Product Change Notification - GBNG-06ZLHV932

CCB 3843 Final Notice: Implement Microchip Packing Changes for selected Microsemi (LCLD, VPT, TIM, WIFI) products.

CCB 3843

Packing Method-Tray

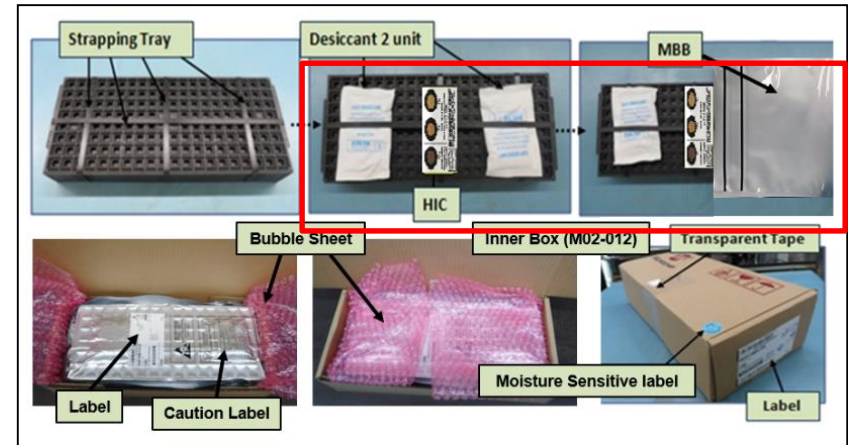
Pack with bubble sheet inside bag

Pack without bubble sheet inside bag

Moisture Barrier Bag (MBB)-Tube

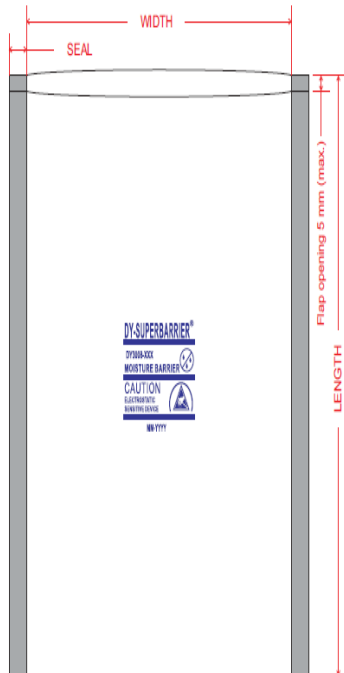
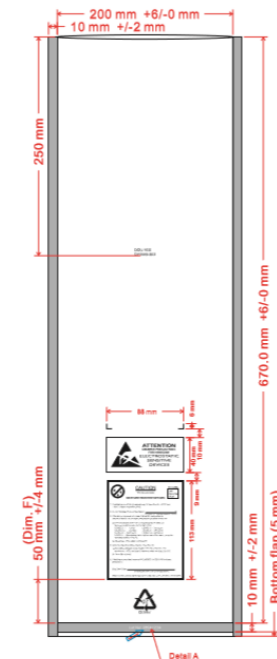
Packing media	Subon	Dimension W x L (mm)
Tube	ASEM	254 x 762

Part no.	Dimension W x L (mm)
24000039	200 x 670

Moisture Barrier Bag (MBB)-7" TnR

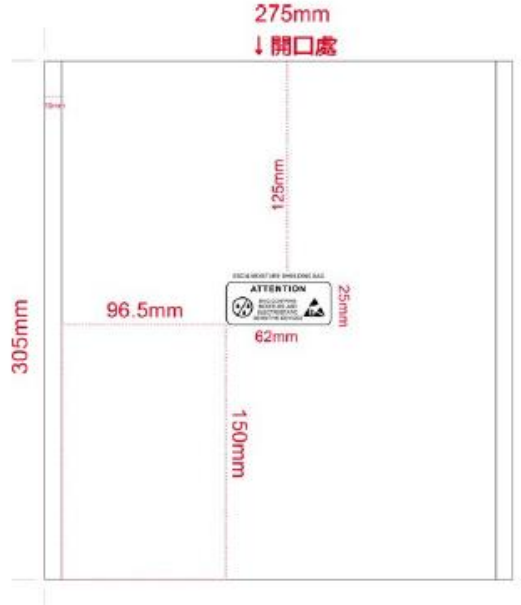
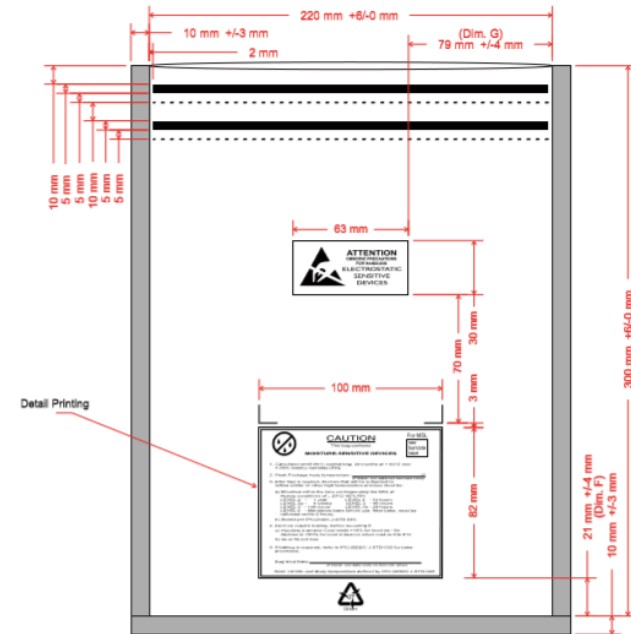
Packing media	Subcon	Dimension W x L (cm)
7" TnR	GIGA	275x305

Part no.	Dimension W x L (cm)
24000046	220 x 300

Moisture Barrier Bag (MBB)-13”TnR

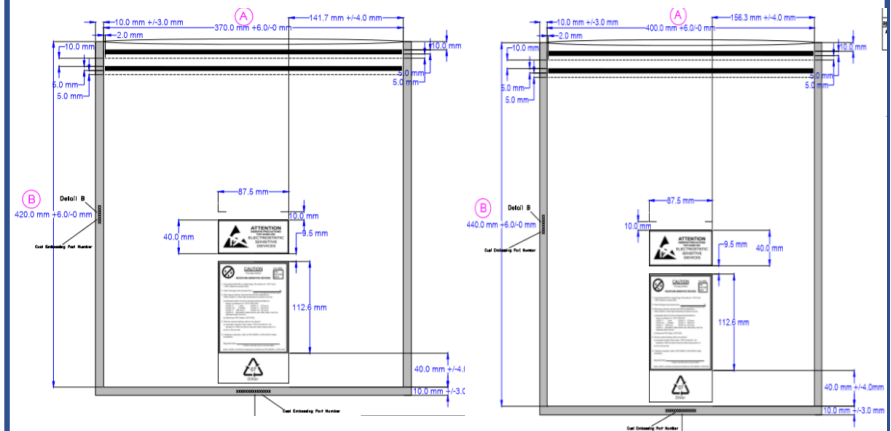
Packing media	Subcon	Dimension W x L (cm)
13”	ASEM	406.4 x 457.2
	UTAC	380 x 445
	GIGA	400x430
	SIGURD	400 x 450

Part no.	Dimension W x L (cm)
24000001 (Small)	370 x 420
24000006 (Large)	400 x 440

Inner Carton for Tube

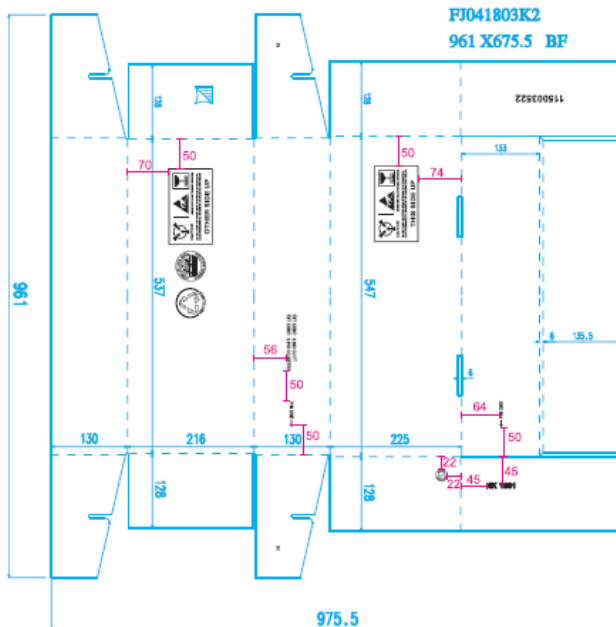
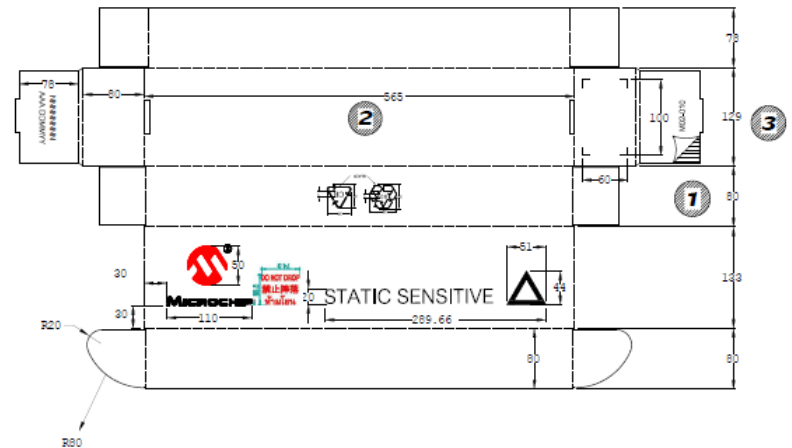
BU	Subcon	Drawing number	Dimension W x L x H (cm)
LCLD, VPT, TIM	ASEM	115003522	21.6 X 53.8 X 13.0

Drawing number	Dimension W x L x H (cm)
M02-010	12.9x56.5x8

Inner Carton for 13" TnR

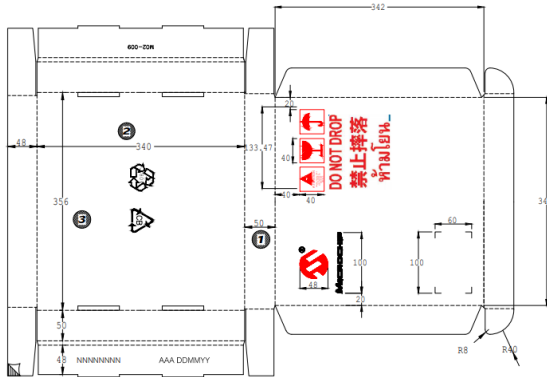
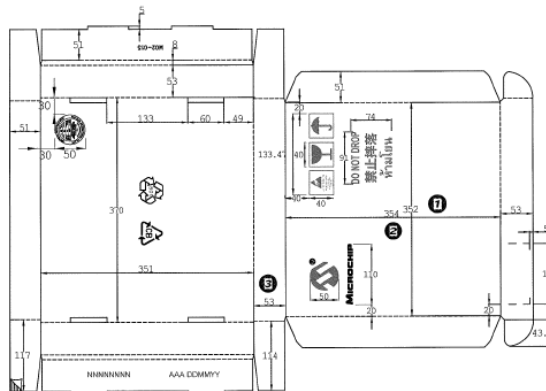
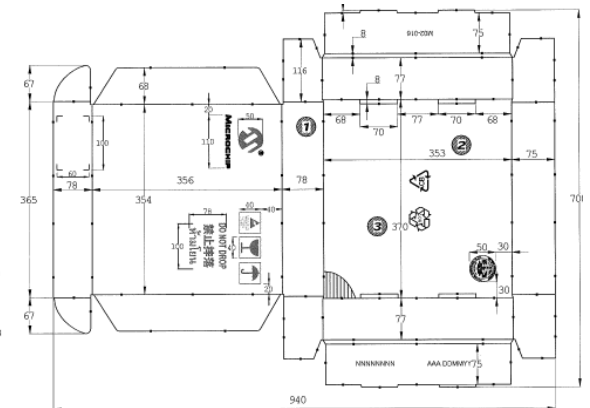
Drawing number	Dimension W x L x H (cm)
M02-009 for Sigurd, GIGA, UTAC	34x35.6x5.0
M02-015 (Small) for ASEM	37x35.1x5.3
M02-016 (Large) for ASEM	37x35.3x7.7

Tray Outer Carton (2:1)

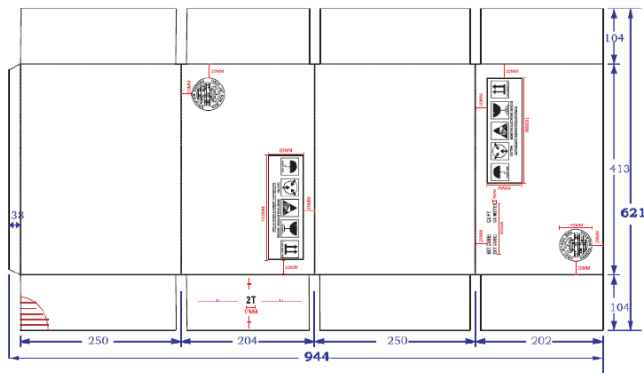
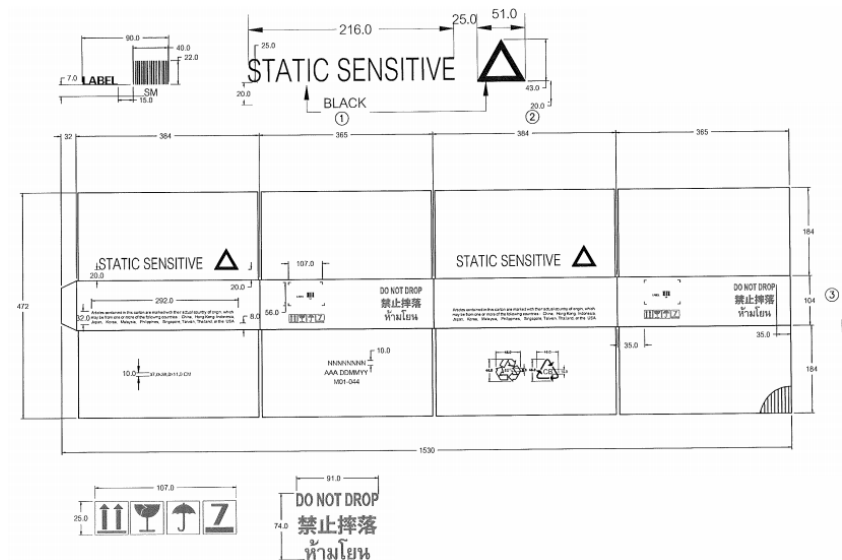
ASEM 2T CARTON DRAWING (250 x 204 x 413 mm)

Width	Length	Height
37.0	38.0	11.0

Drawing number: M01-044

Outer Carton for Tube (1:1)

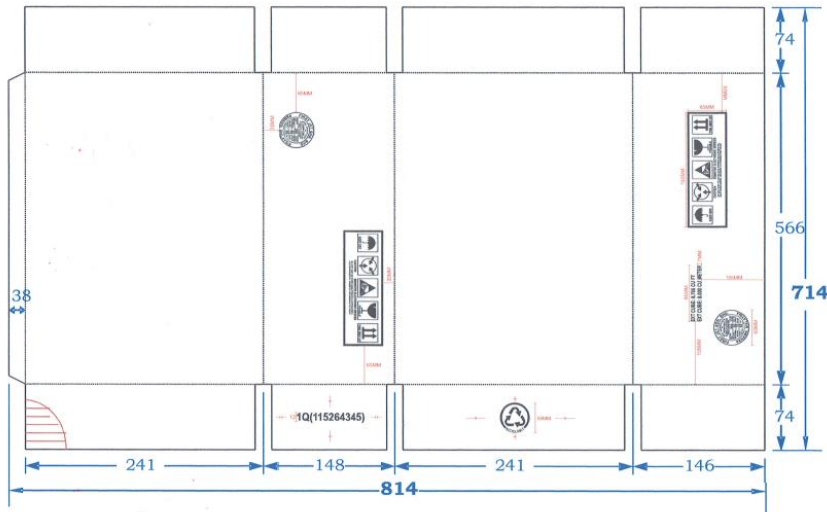
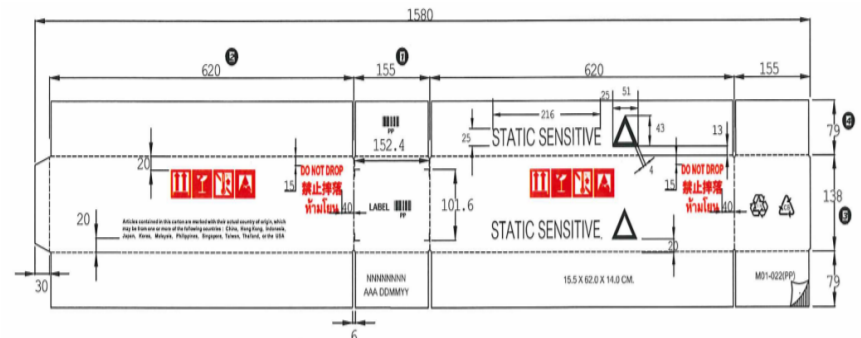
BU	Subcon	Drawing number	Dimension W x L x H (cm)
LCLD, VPT, TIM	ASEM	115264345	24.1x56.6x14.8

Drawing number	Dimension W x L x H (cm)
M01-022 (PP)	15.5x62.0x14.0

Outer Carton for Tube (2:1)

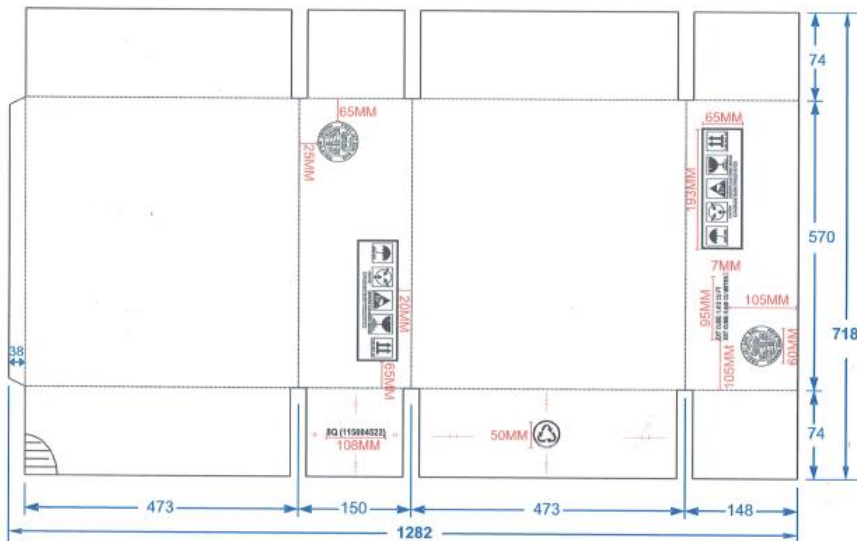
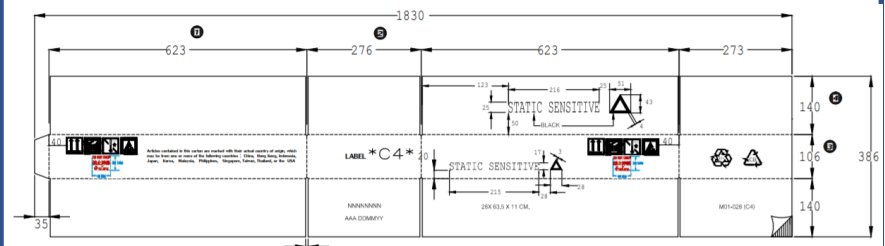
BU	Subcon	Drawing number	Dimension W x L x H (cm)
LCLD, VPT, TIM	ASEM	115004522	47.3x57.0x15.0

Drawing number	Dimension W x L x H (cm)
M01-028 (C4)	28x63.5x11

Outer Carton for Tube (4:1)

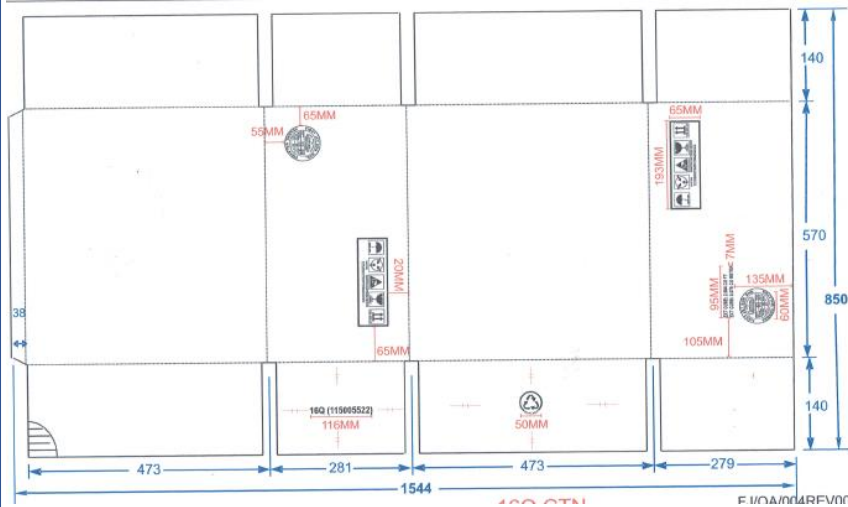
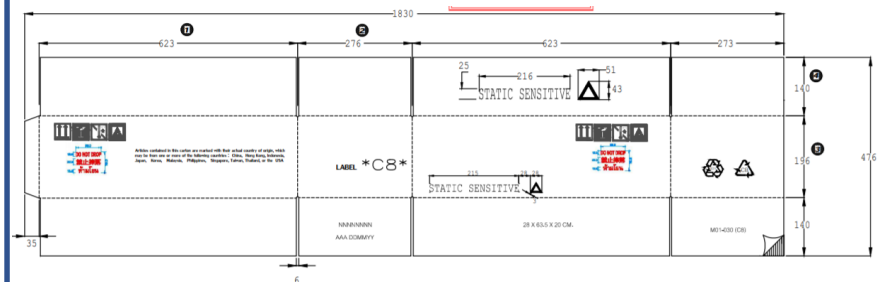
BU	Subcon	Drawing number	Dimension W x L x H (cm)
LCLD, VPT, TIM	ASEM	115005522	47.3x57.0x28.1

Drawing number	Dimension W x L x H (cm)
M01-030 (C8)	28x63.5x20

Outer Carton for Tube (6:1)

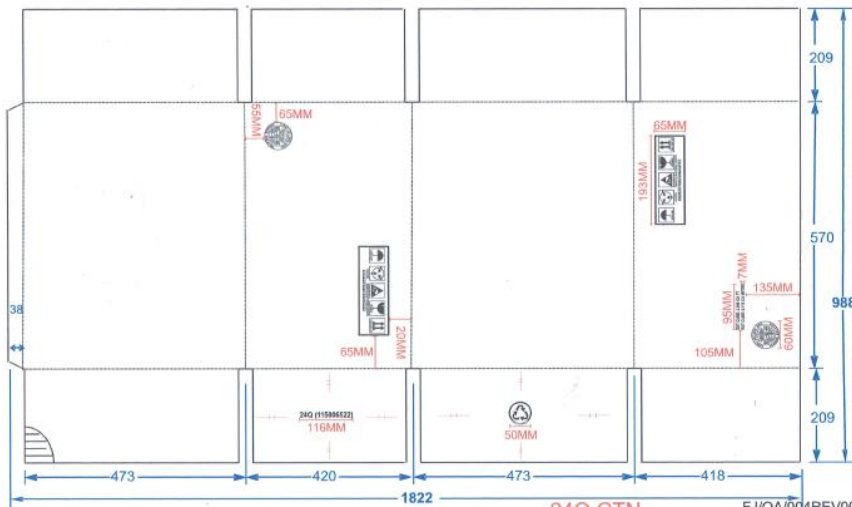
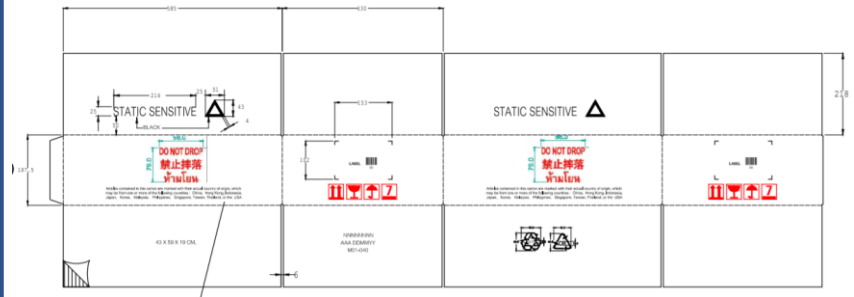
BU	Subcon	Drawing number	Dimension W x L x H (cm)
LCLD, VPT, TIM	ASEM	115006522	47.3x57.0x42.0

Drawing number	Dimension W x L x H (cm)
M01-040 (S6)	43x59x19
